Field campaign

Topic	EPAS harness over check Continental GT 26MY (SC26/01)
Market area	United States E05 Bentley USA and rest America (6E05)
Brand	Bentley
Transaction No.	2080623/1
Campaign number	ED80
Note	
Type	
US code

Continental GT

Figure 1. *Subframe support fixings*

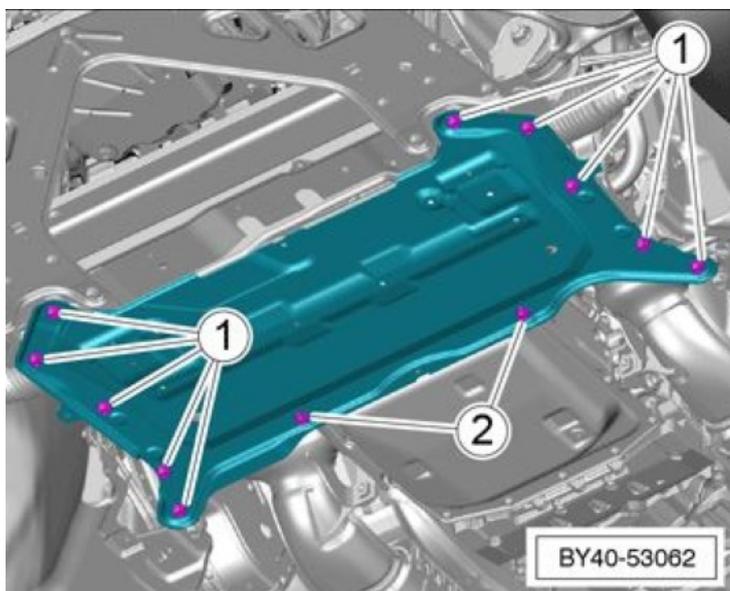
– Remove the fixings -1- (30 Nm) and -2- (30 Nm).

– Remove the subframe rear support.

Figure 2. (Image shows correct harness orientation) Electro-mechanical power steering (ePAS) harness location,

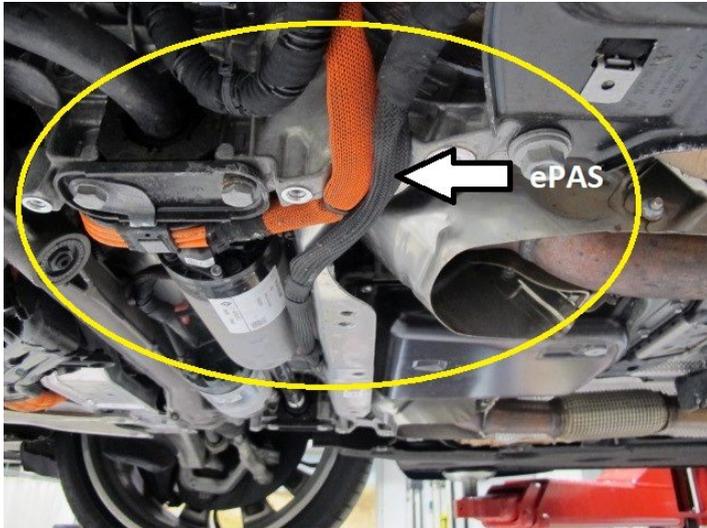
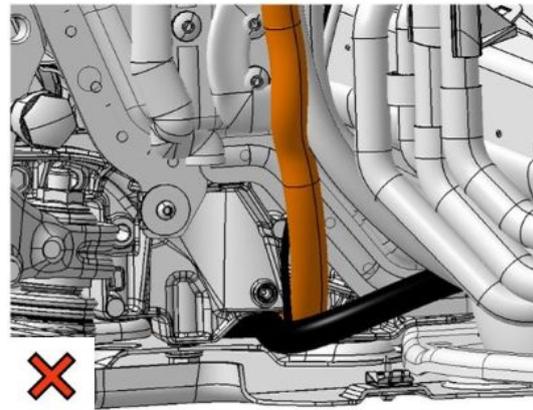
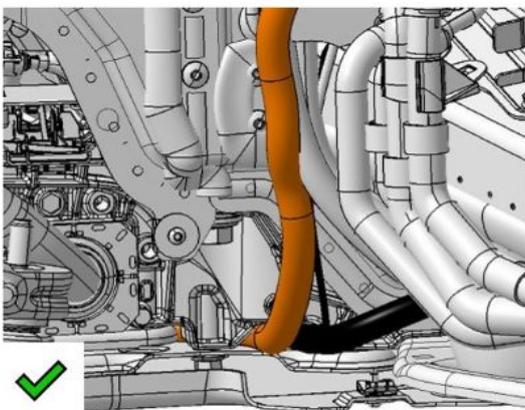
5. Locate ePAS harness and confirm orientation.

Figure 3. OK and NOK visuals

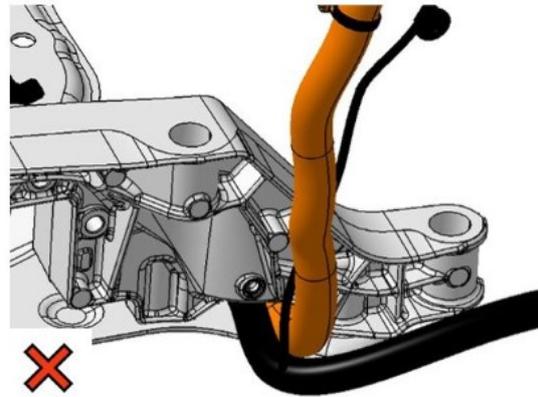
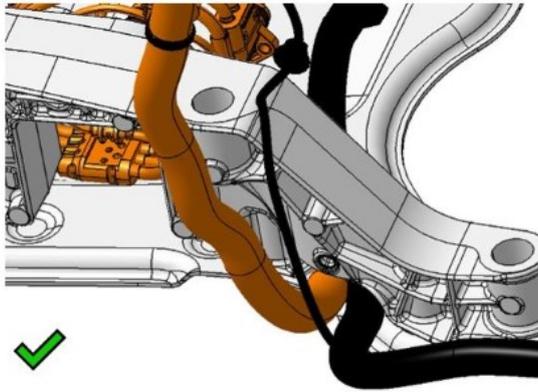
Confirm the ePAS harness orientation is incorrect for the vehicle hand of drive (see Fig 3.).

6. Correct routing should follow LHD specification, see OK and NOK visuals below for reference.

7. Remove cable tie bracket(s) securing the harness.
8. Carefully reposition harness to correct orientation:

9. Ensure harness follows the factory routing path and is clipped into all designated retainers.

10. Refit cable tie bracket and confirm harness is free from obstruction.

Figure 4. Front Subframe support to steering rack harness location

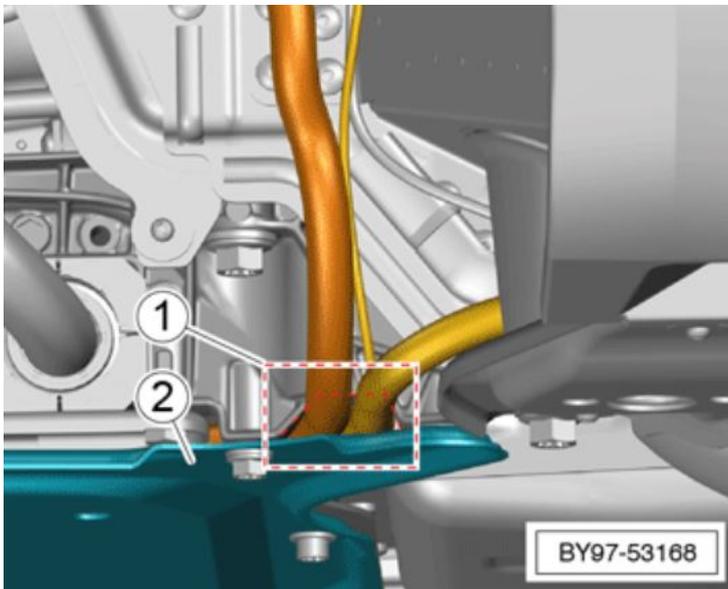
- Clean mating surfaces between all supports and subframe.
- Ensure the anti-roll bar wiring and steering rack harness is positioned correctly between the subframe -1- and the subframe rear support -2- to avoid any trapping/pinching etc. See figure 4.

Figure 5. Campaign completion identification marking

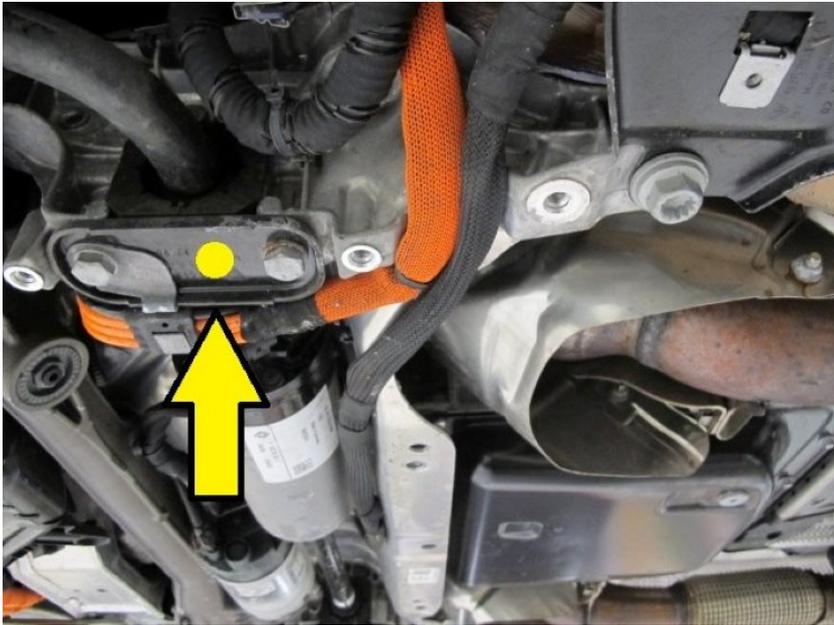
Apply a yellow paint completion mark on the underside of the left-hand anti roll bar mounting bracket as shown below.
